Proposed Residential Flat Building Development

17 – 21 Shirley Road, Roseville

Transport and Parking Impact Assessment

The report has also been updated to address Council's RFIs during the preliminary assessment (DA0190/25) (See Appendix A). The RFIs and associated TS responses are provided in the following table:

Figure 2: Possible alternative massing (diagonal height differential indicated)

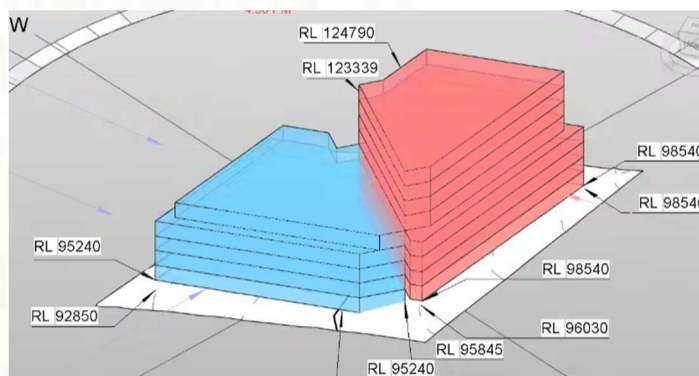
1. The intended 18.5m height limit for No. 19–21 Shirley Road under Council's TOD Alternative responds to site topography and aims to minimise overshadowing of neighbouring properties to the south and east, which are limited to heights of 12m and 9.5m (**Figure 1**). **The proposed draft**

alternative massing appears to extend the full 29m height diagonally across the site, approaching the Shirley Road corner (Figure 2). This response is not as envisaged by Council's Strategic Planning team under the TOD Alternative which proposed a reduced height of 18.5m at the Shirley Road corner. This raises concerns in relation to potential overshadowing impacts on Nos. 22 and 25 Shirley Road. Additional overshadowing analysis and testing are required if Council is to consider amendments to building massing as suggested.

DRAWING TITLE			
Basement 3 GA Plan			
DATE	DRAWN BY	APPROVED BY	TRUE NORTH
12/09/2025	CG	MM	
SCALE	SHEET SIZE	PROJECT NO.	
As Indicated	A1	2503	
DRAWING NO.	REVISION NO.

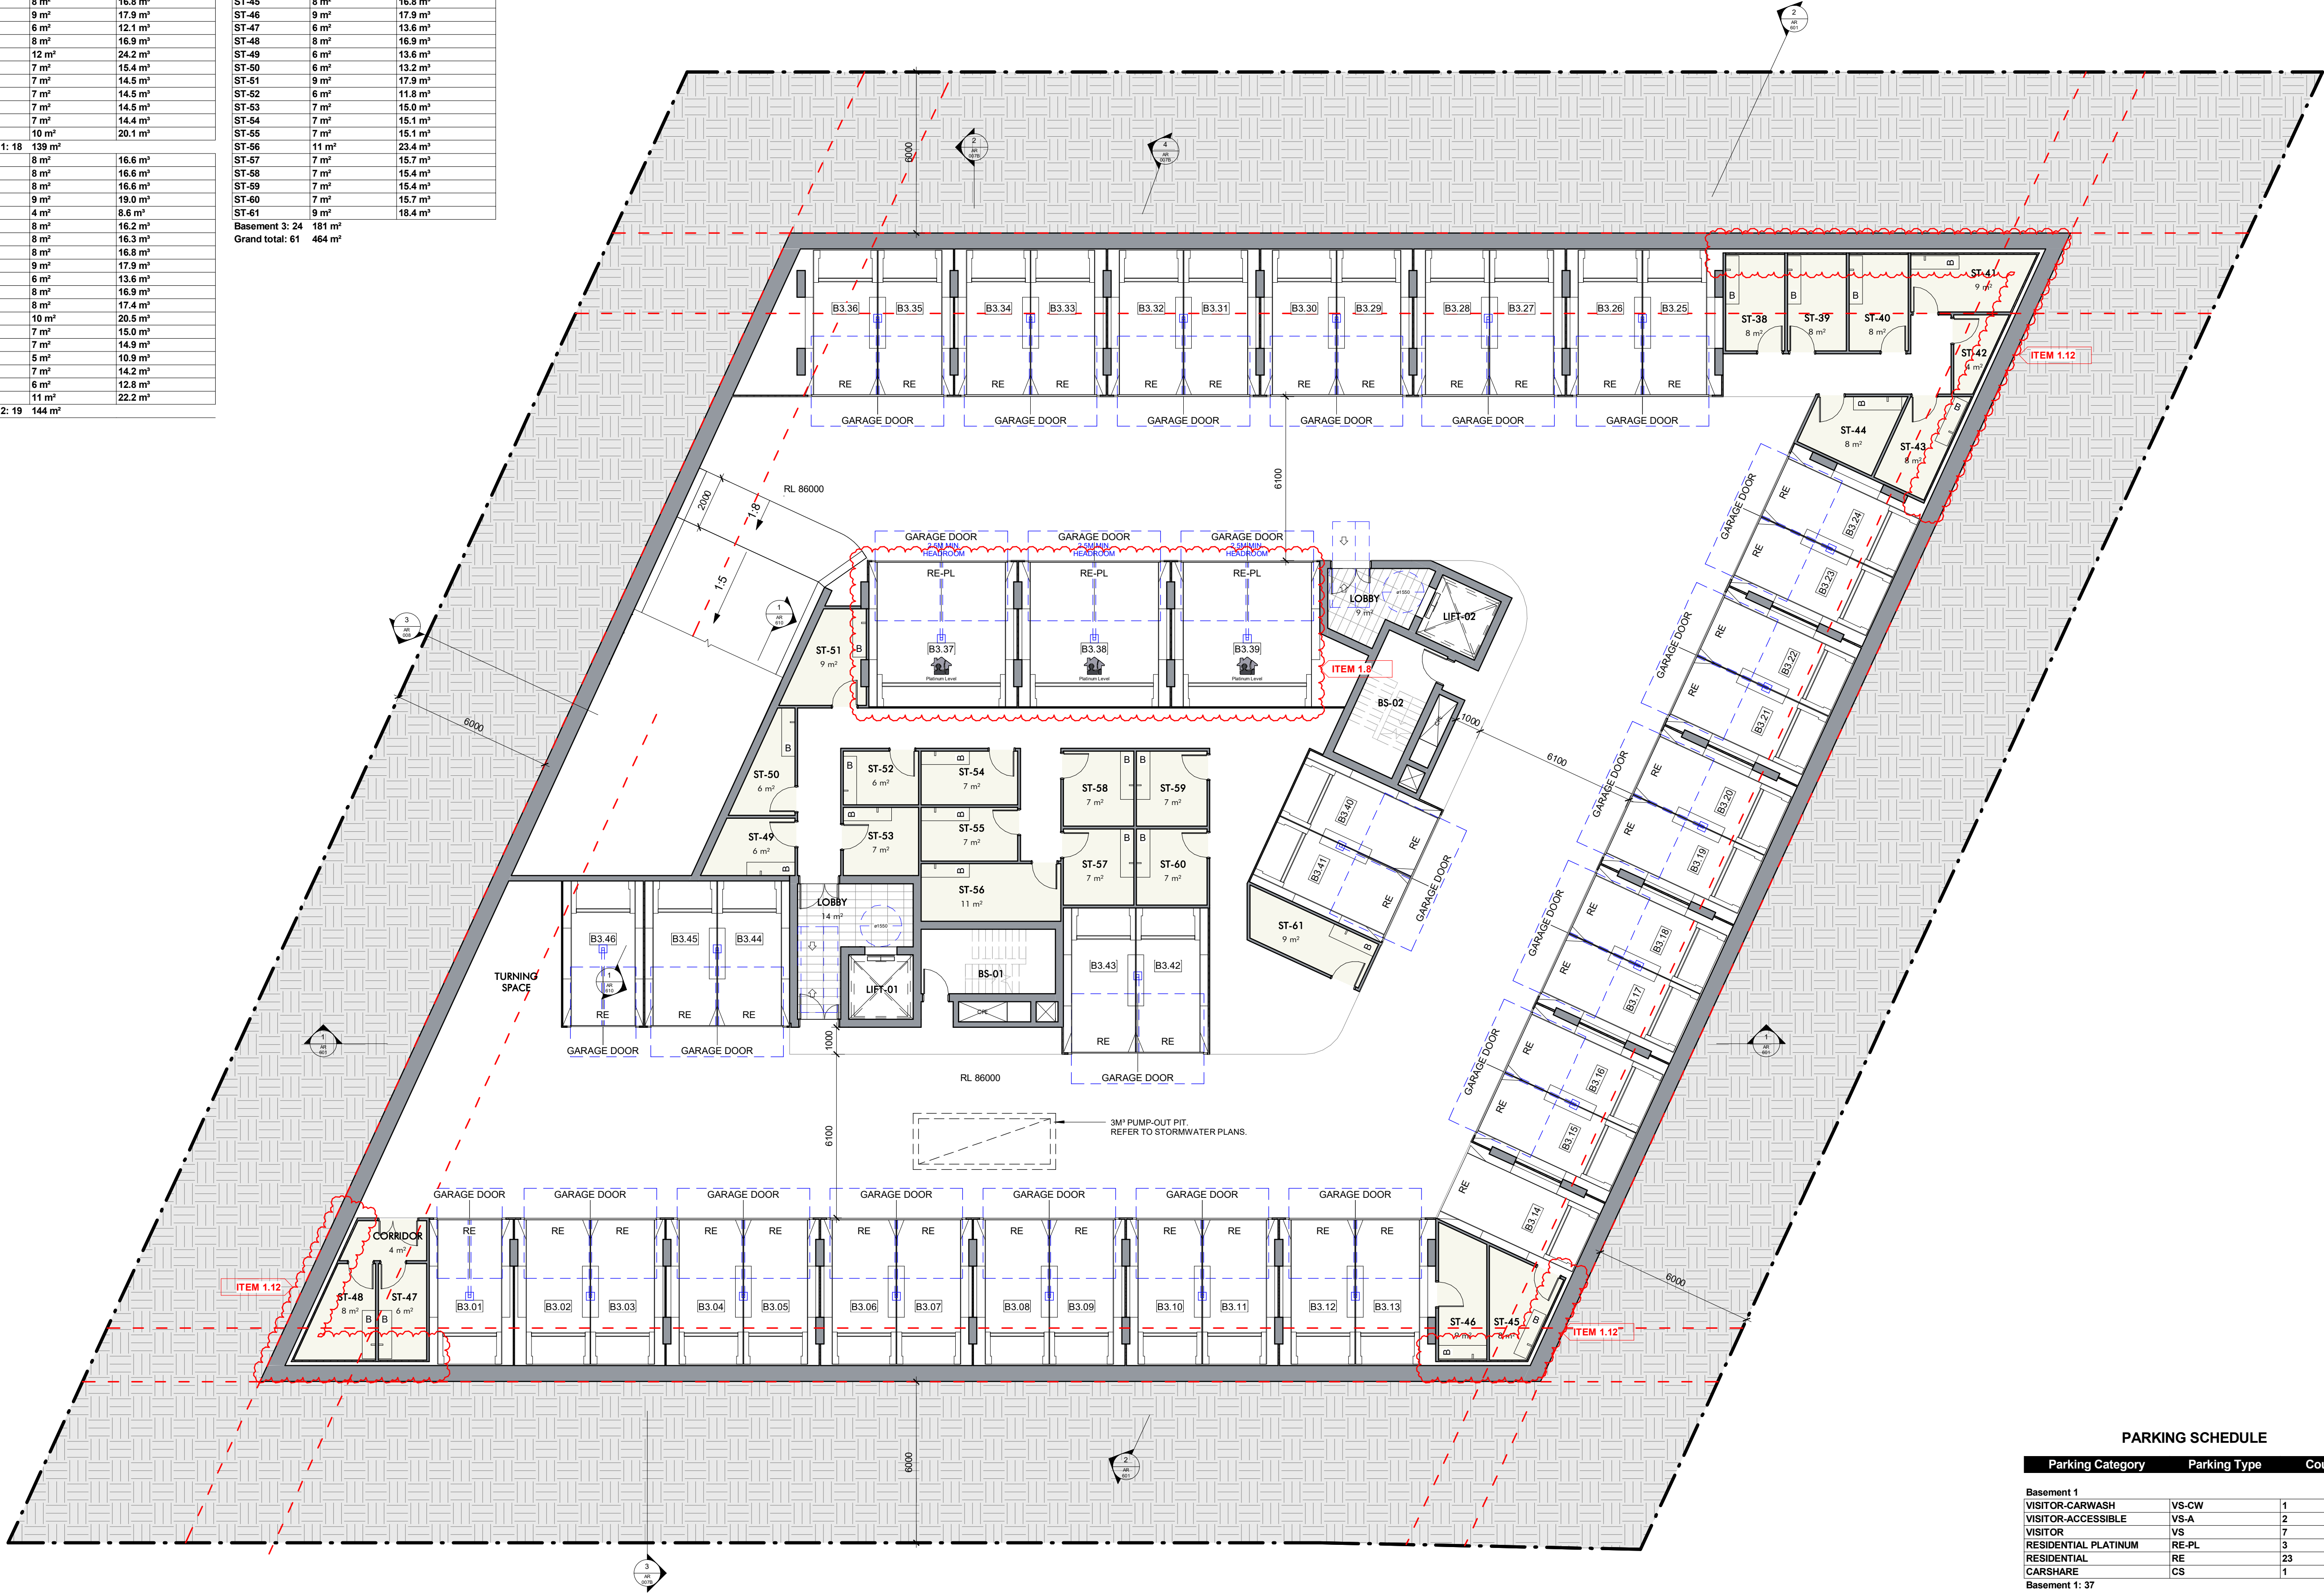
ITEM 4.1	QSD revised per Council comments. Refer Stormwater engineer's documentation.	AR 103, Stormwater Drawings
ITEM 4.2	Parking layout revised. Excess car spaces shown as GFA, subject to clause 4.6 prepared by the Town Planner.	AR 007, AR 100, AR 101, AR 102

17-21 SHIRLEY ROAD, ROSEVILLE
BASEMENT 2
COMPLIANCE REVIEW & SWEEP PATH ASSESSMENT

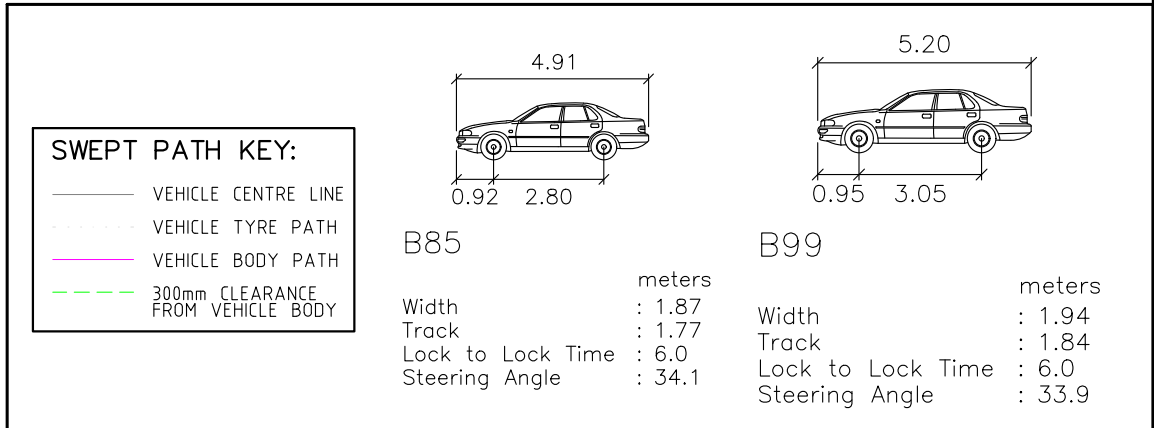
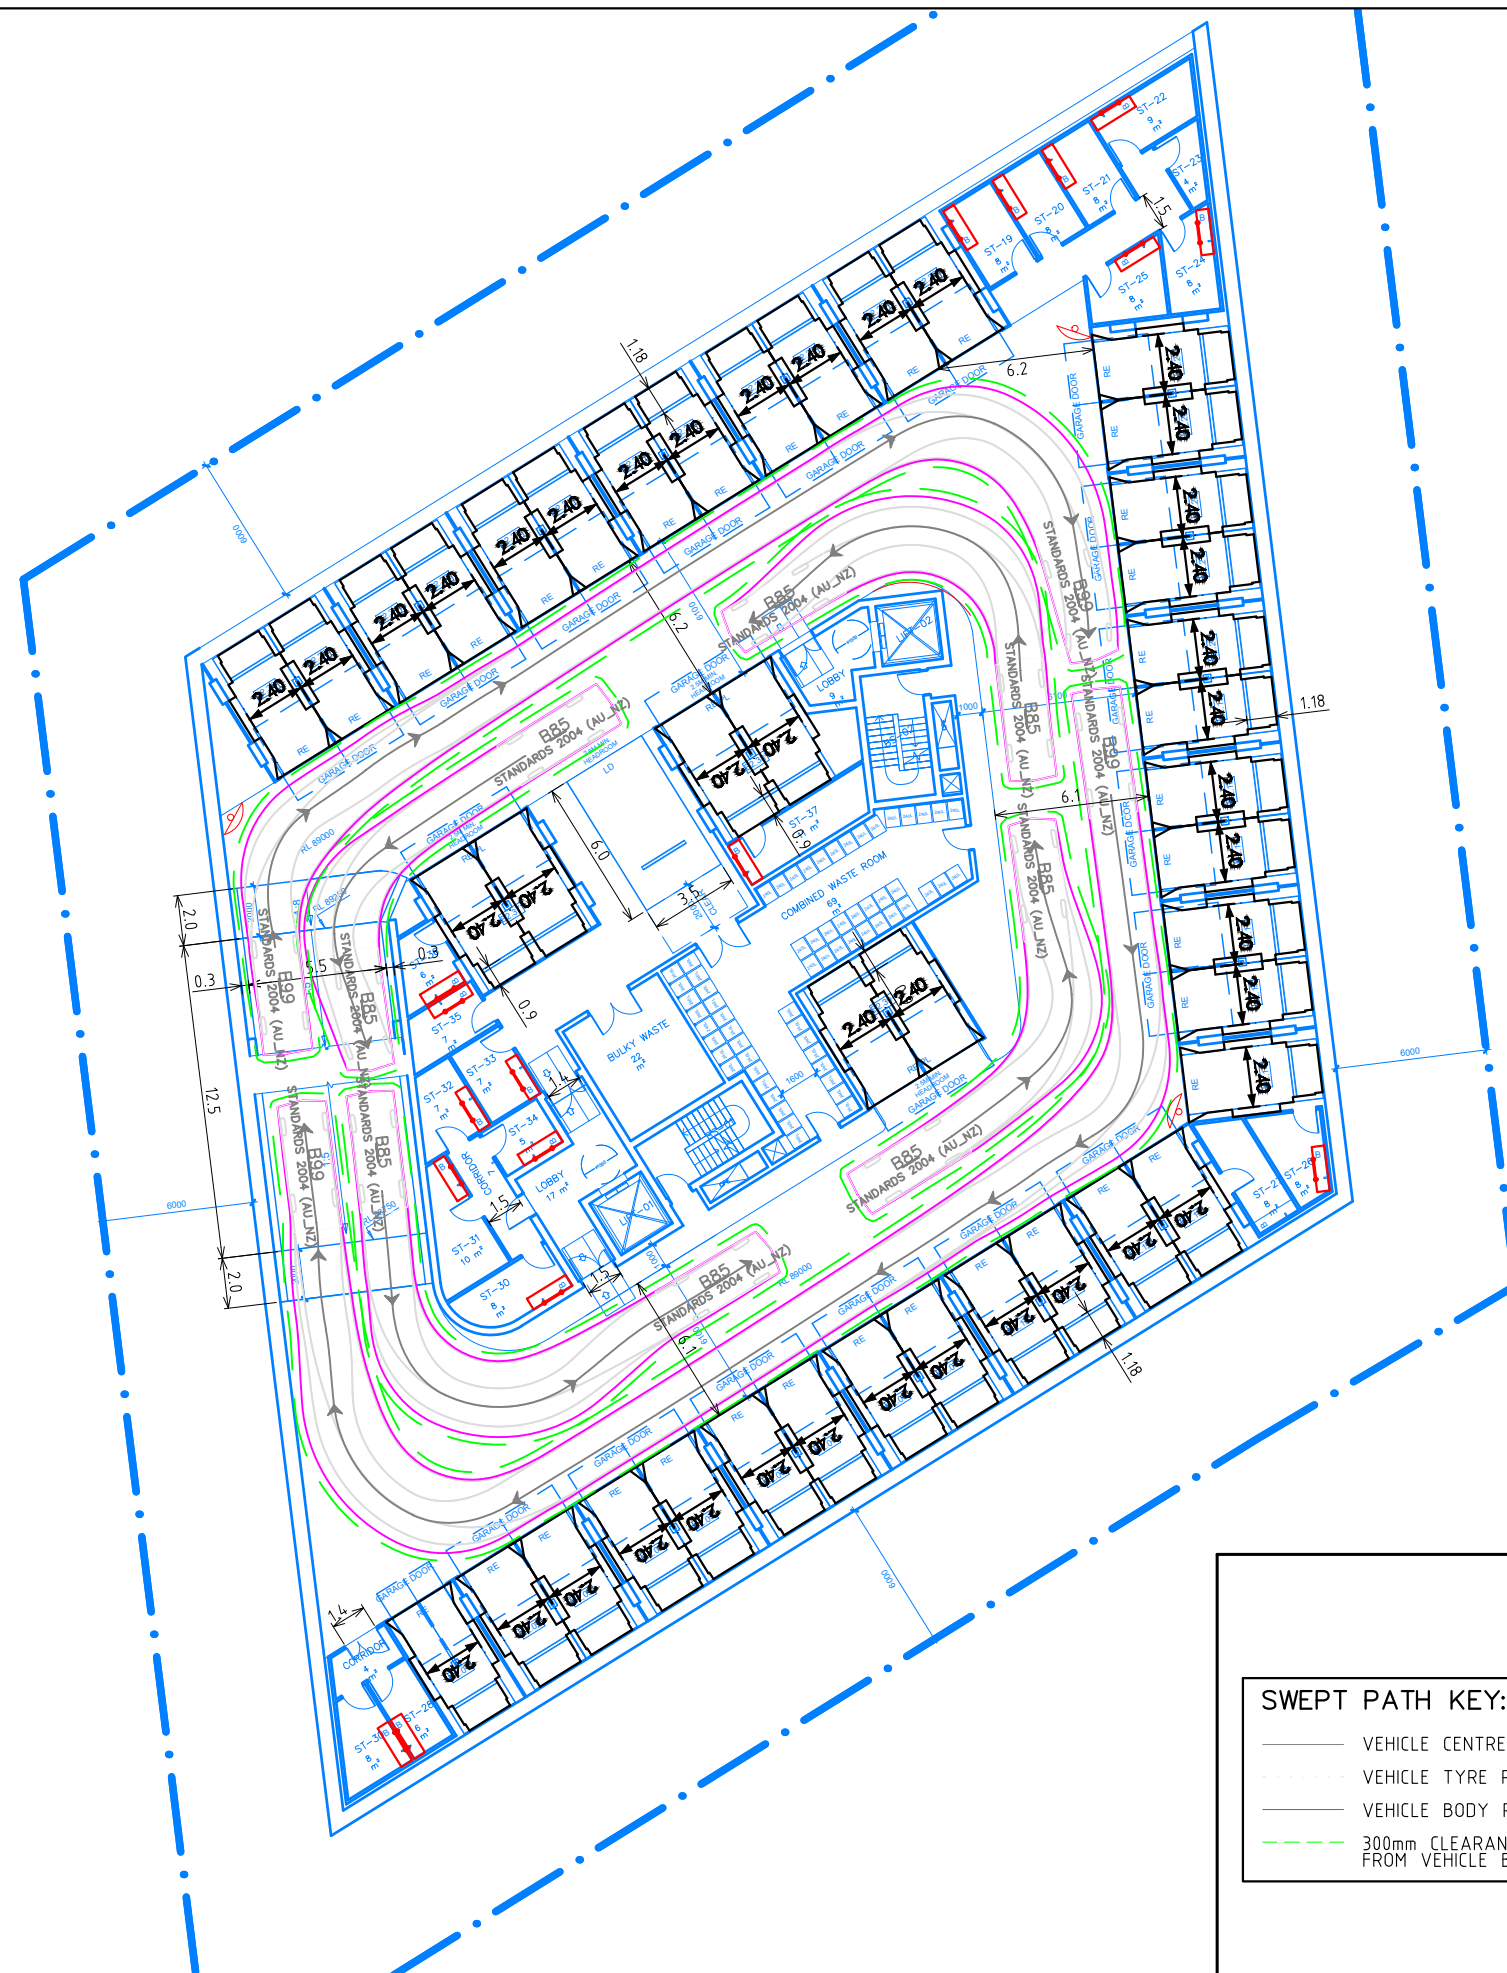
PROVIDE CONVEX MIRROR AS SHOWN

PROVIDE 1.5M ACCESS WIDTH

PROVIDE CONVEX MIRROR AS SHOWN

PROVIDE CONVEX MIRROR AS SHOWN

PROVIDE CONVEX
MIRROR AS SHOWN

PROVIDE 1.5M
ACCESS WIDTH

PROVIDE CONVEX
MIRROR AS SHOWN

PROVIDE CONVEX
MIRROR AS SHOWN
